## **ORIGINATION FORM**

Proposed Revisions to a Standard Plans Index (Please provide all information – Incomplete forms will be returned)

# Index Number: **219** Sheet Number (s): 1,2 Index Title: Concrete Barrier Wall Inlet

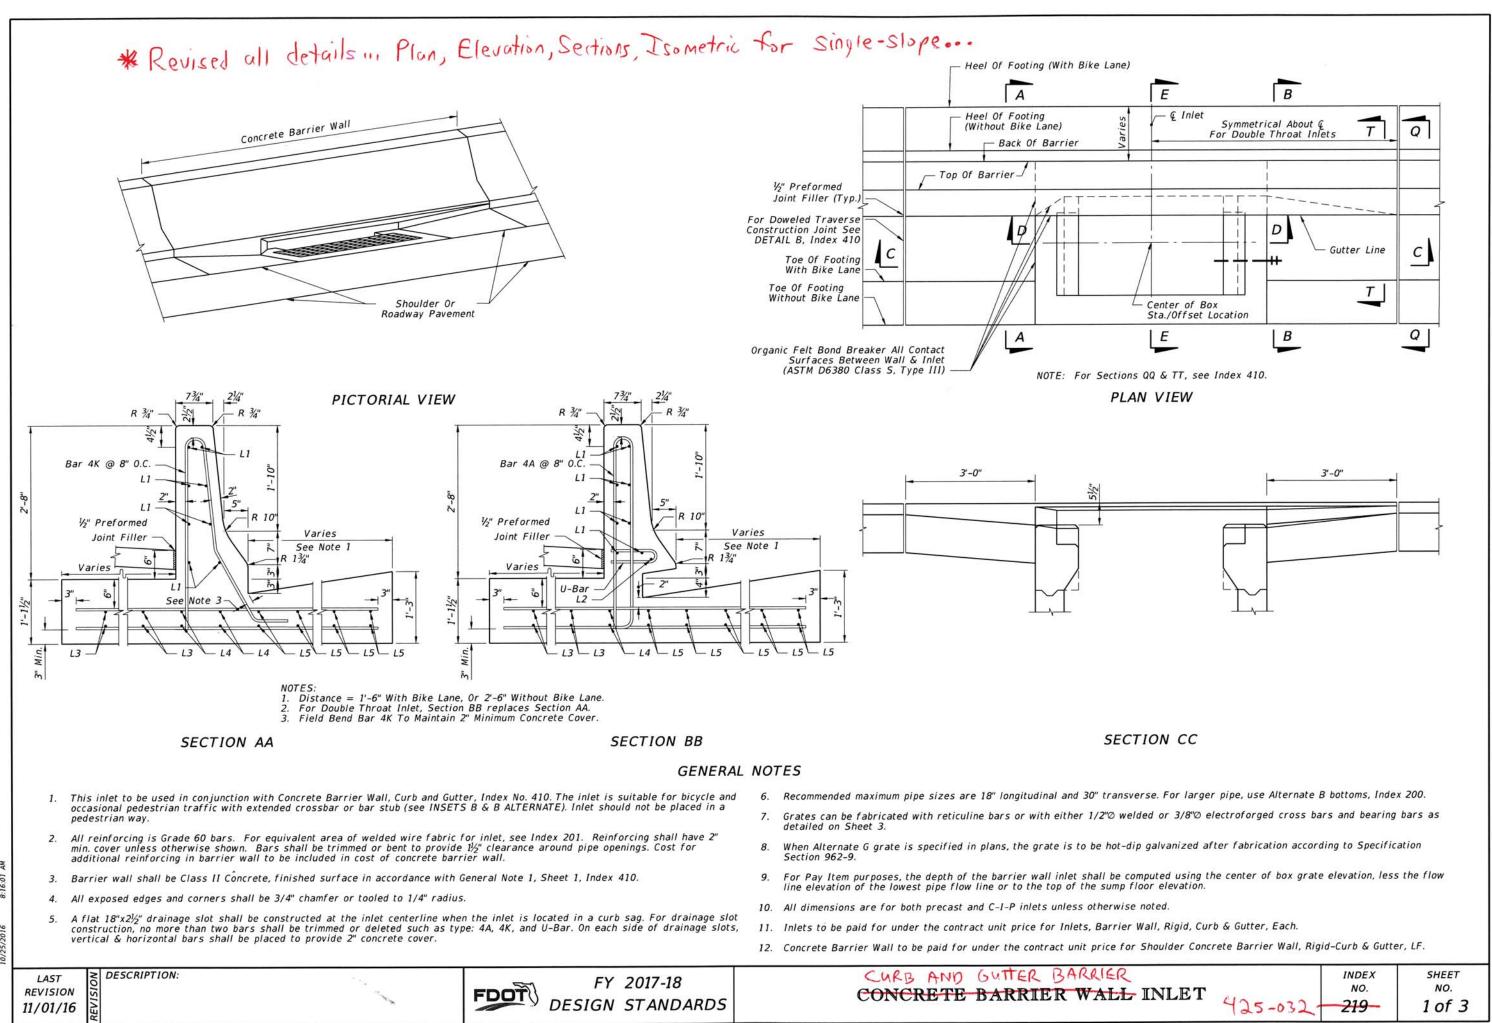
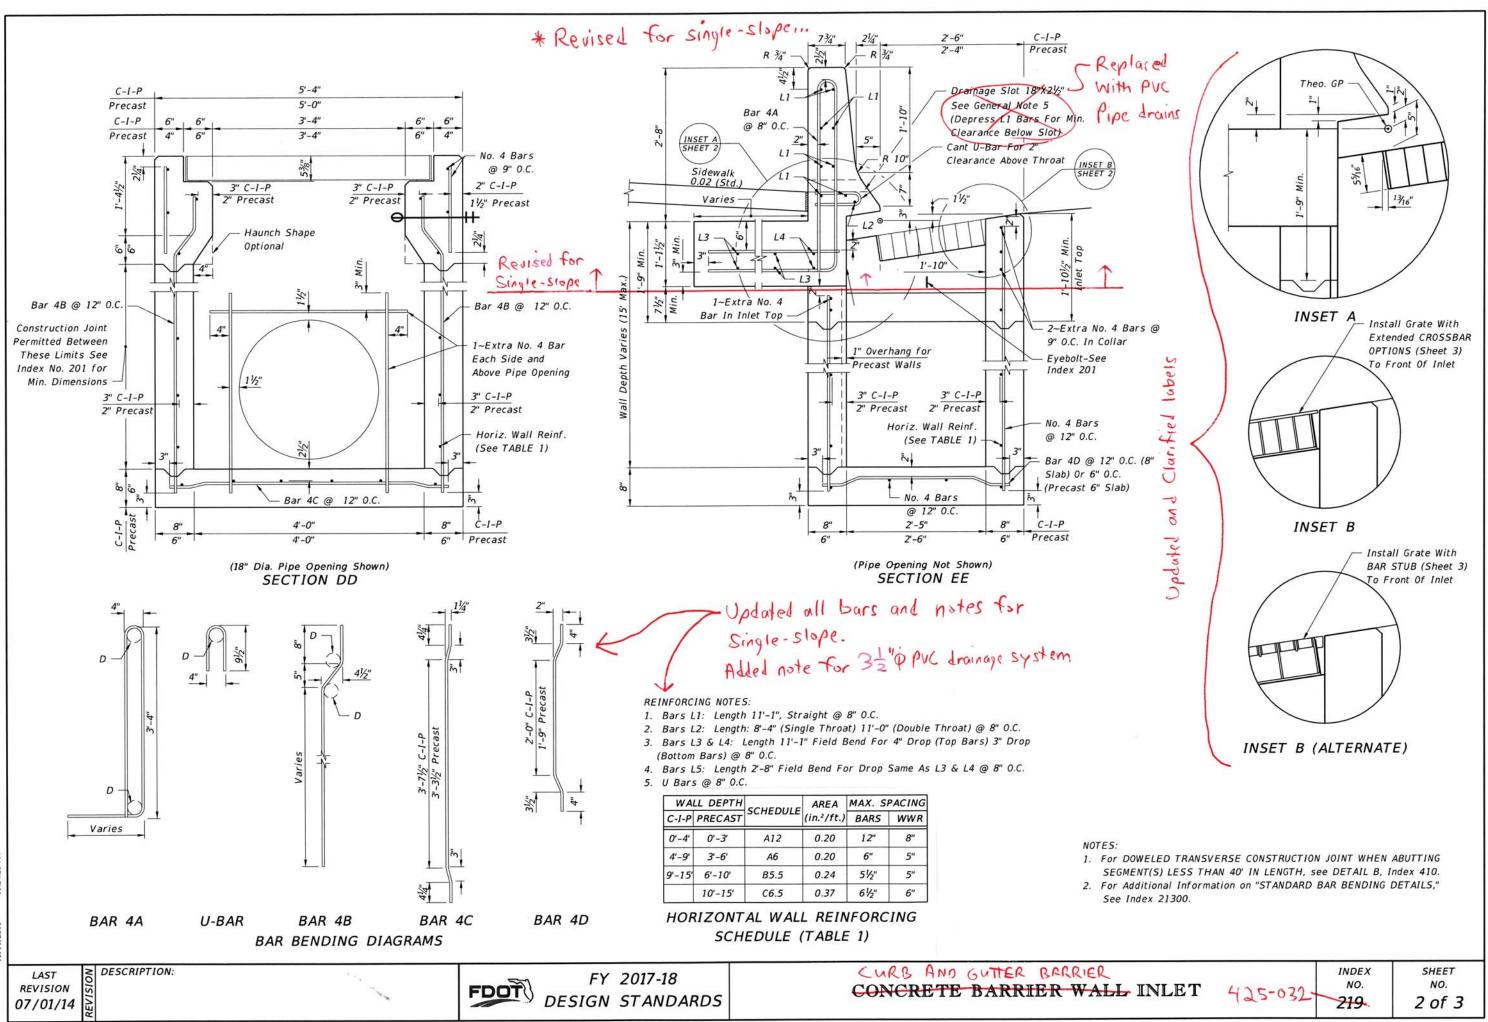
- 1. Update concrete sections and reinforcing steel for new Single-Slope Barrier. Clarify drawing labels.
- 2. Replace 18" wide Drainage Slot with 3 qty. PVC Pipes to improve concrete and reinforcing steel continuity.
- 3. Remove upstream throat.
- 4. Change Index name to "Curb & Gutter Barrier Inlet" to better describe function with new Concrete Barrier Index
